**Lakeside Pump Station and Force Main  
Mascoutah, Illinois  
ADDENDUM #1  
September 9, 2020**

**TO: PROSPECTIVE BIDDERS**

**FROM: City of Mascoutah / Millennia Professional Services**

<b>LAKESIDE ESTATES PUMP STATION PLAN EXHIBIT</b>	
	<b>Millennia Professional Services</b>
	11 Executive Drive, Suite 12 Fairview Heights, Illinois 62208 (618)624-8610 FAX: (618)624-8611
	DRAWN: S.J. CHKD.: T.J.L. APPD.: E.R.O. JOB NO.: ME19039 DATE: 9/9/2020 SHEET 1 OF 1

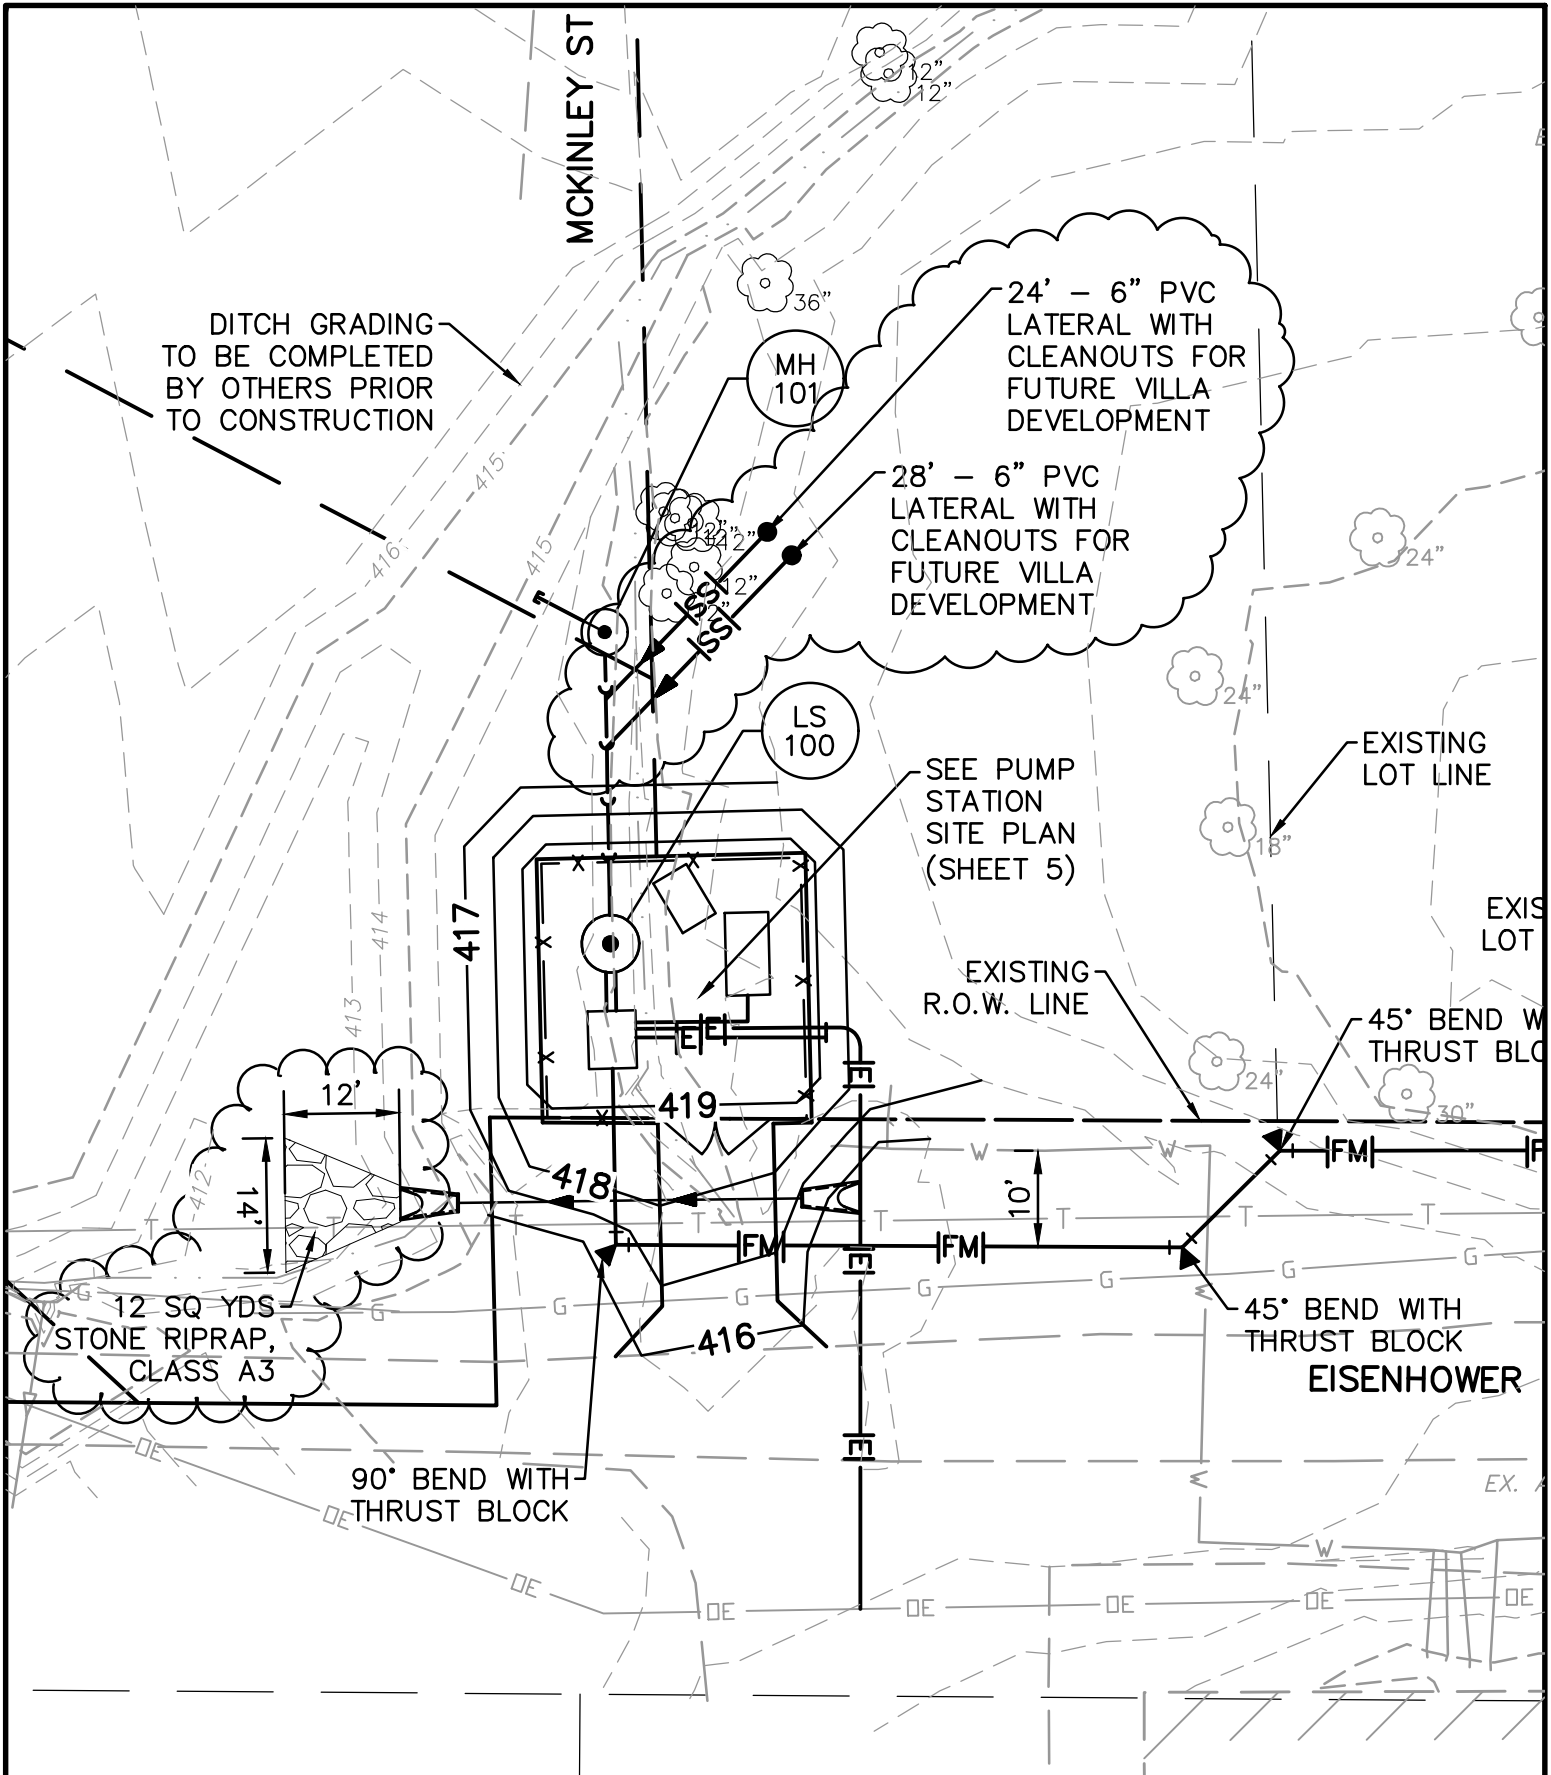
1. Plan Exhibit :
  - a. See the attached exhibit for the updated sewer lateral layout. The quantity is updated under Item No. 2.03 in the Bid Documents (see attached updated sheet 004100-3 of Bid Documents)

- b. See the attached exhibit for riprap placement and dimensions. The quantity is listed under Item No. 2.11 in the Bid Documents (see attached updated sheet 004100-3 of Bid Documents)

24' - 6" PVC  
LATERAL WITH  
CLEANOUTS FOR  
FUTURE VILLA  
DEVELOPMENT

28' - 6" PVC  
LATERAL WITH  
CLEANOUTS FOR  
FUTURE VILLA  
DEVELOPMENT

12 SQ YDS  
STONE RIPRAP,  
CLASS A3

**LAKESIDE ESTATES PUMP STATION  
PROFILE EXHIBIT**

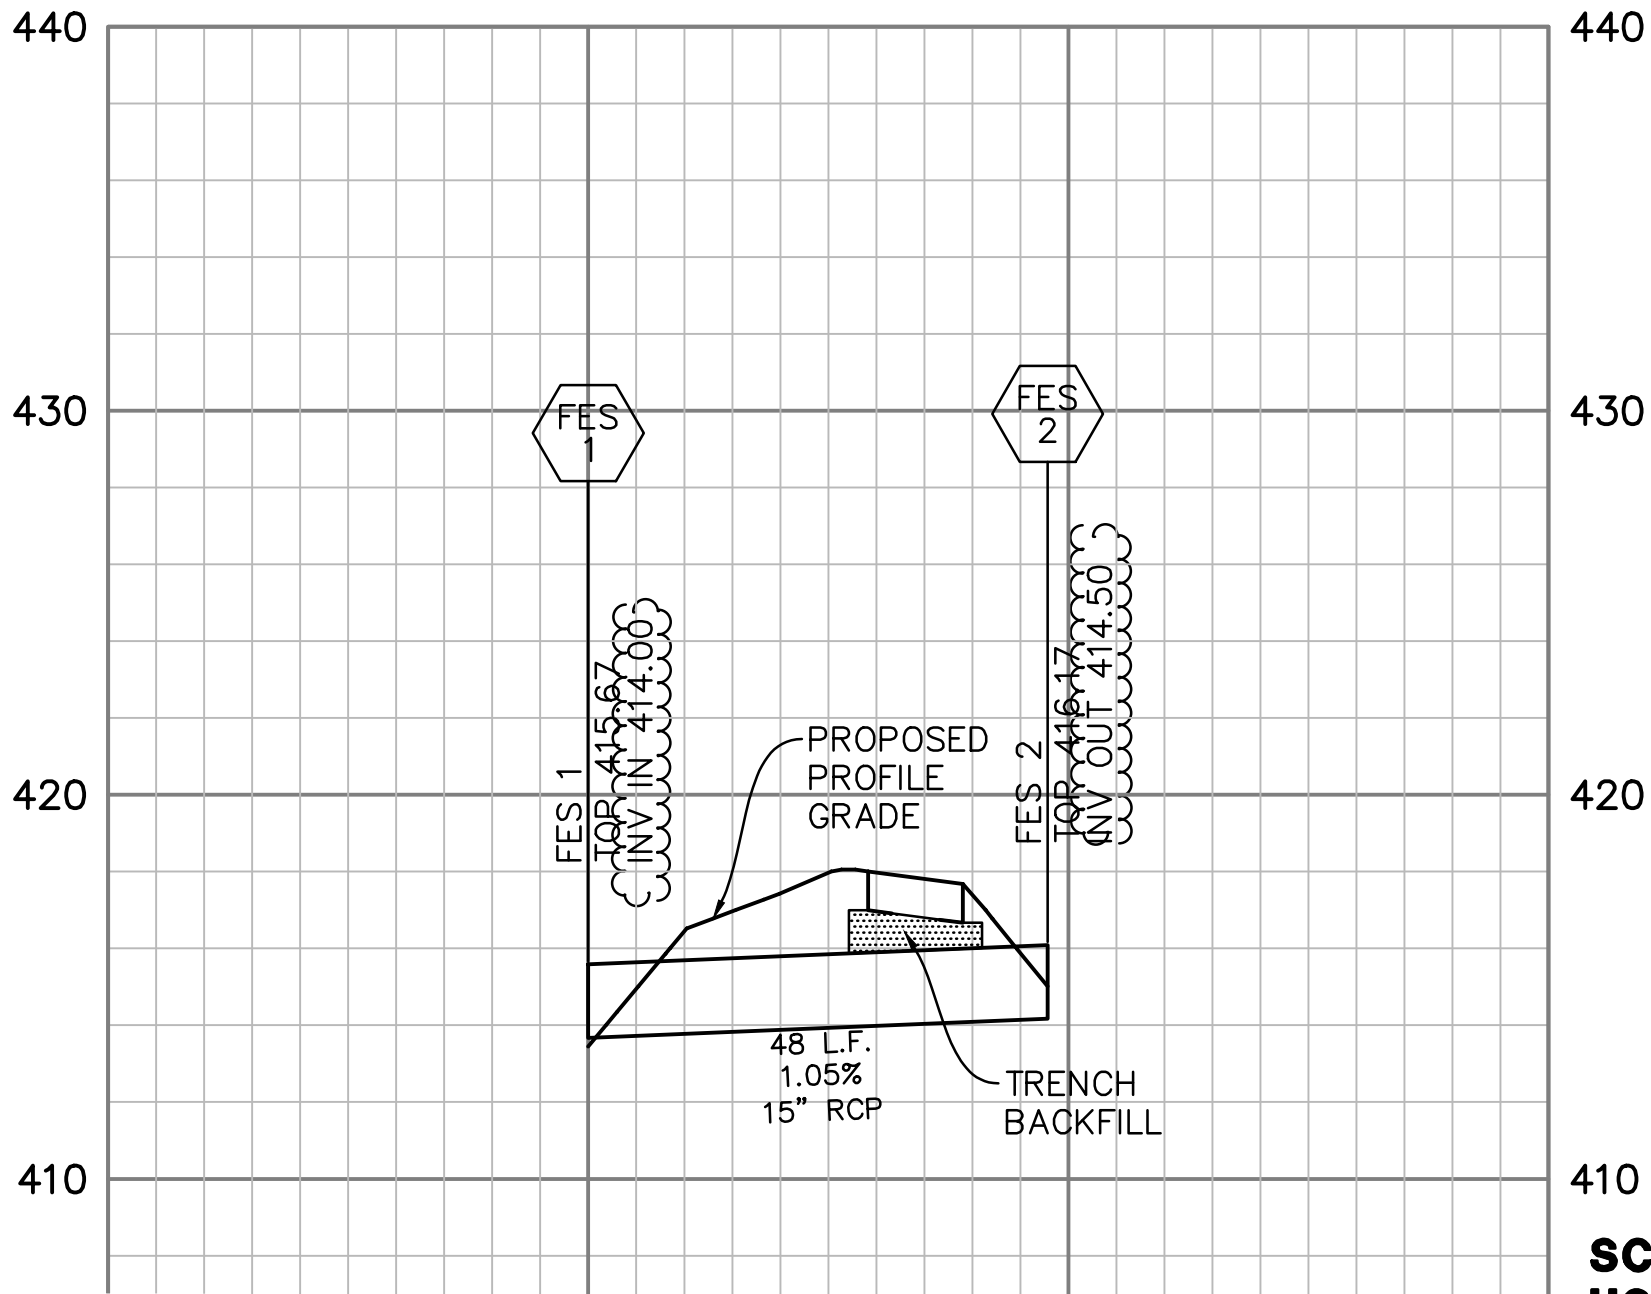
2. Profile Exhibit
  - a. See the attached exhibit for updated invert information on the storm sewer profile. The quantities were not affected by this change.
